**Ground connection for pick-up wiring, Rotax Engine Series Type 912****Mandatory**

- Subject:** improvement of ground connection for the screening braid of pick-up wiring and charging cable
- Engines affected:** All engines of Series 912 A, beginning with engine no. **4,076.064**, since introduction of the SMD-ignition unit.

AIRWORTHINESS DIRECTIVE

Subject: **SMD-Ignition for Rotax 912 A Series, Engines beginning with S/N 4,076.064 and subsequent_**

Instruction for rework

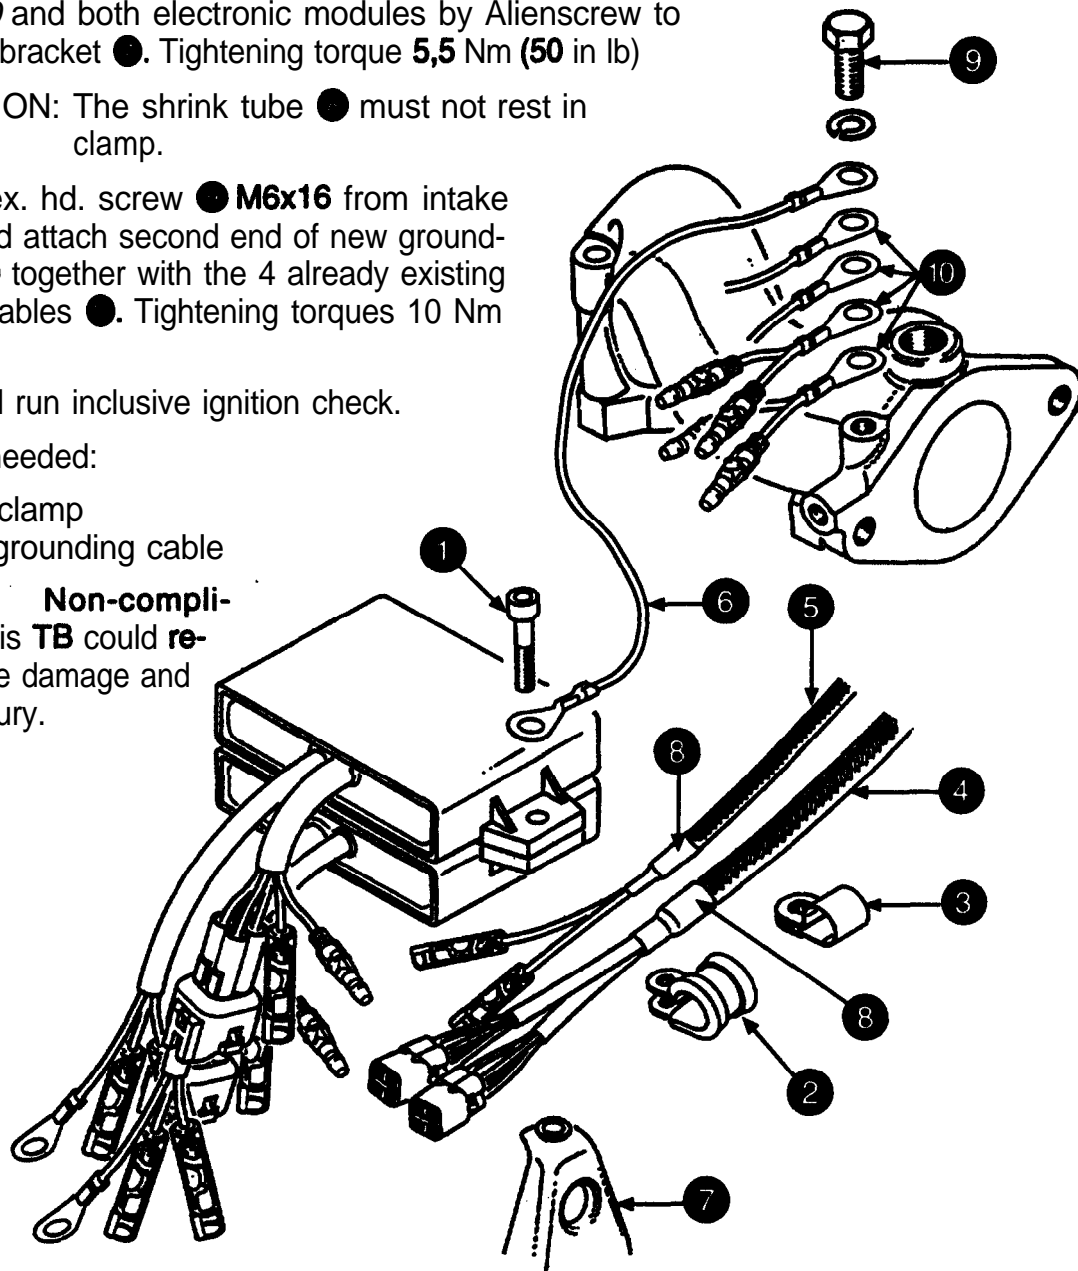
- 1) Remove Allen screw ● **M5x25** and the clamp ● with **rubberlined** inside.
- 2) Slide new clamp ● (without rubberlining) over the cable-assemblies ● and ● so far that the screening braid rests completely in the clamp.
- 3) The **shorting** cables have to be furnished with screening over the complete length. The **screening** to be attached via short connection prices on the Alien screw ● together with grounding cable ●. On the ignition switch side the screening of the shorting cable has to be securely connected to ground too.
- 4) Attach new grounding cable ● *part-no. 965 787*, damp ● *part-no. 8511 79* and both electronic modules by Alienscrew to ignition coil bracket ●. Tightening torque **5,5 Nm (50 in lb)**

■ **ATTENTION:** The shrink tube ● must not rest in clamp.

- 5) Remove hex. hd. screw ● **M6x16** from intake manifold and attach second end of new grounding cable ● together with the 4 already existing grounding cables ●. Tightening torques **10 Nm (90 in lb)**
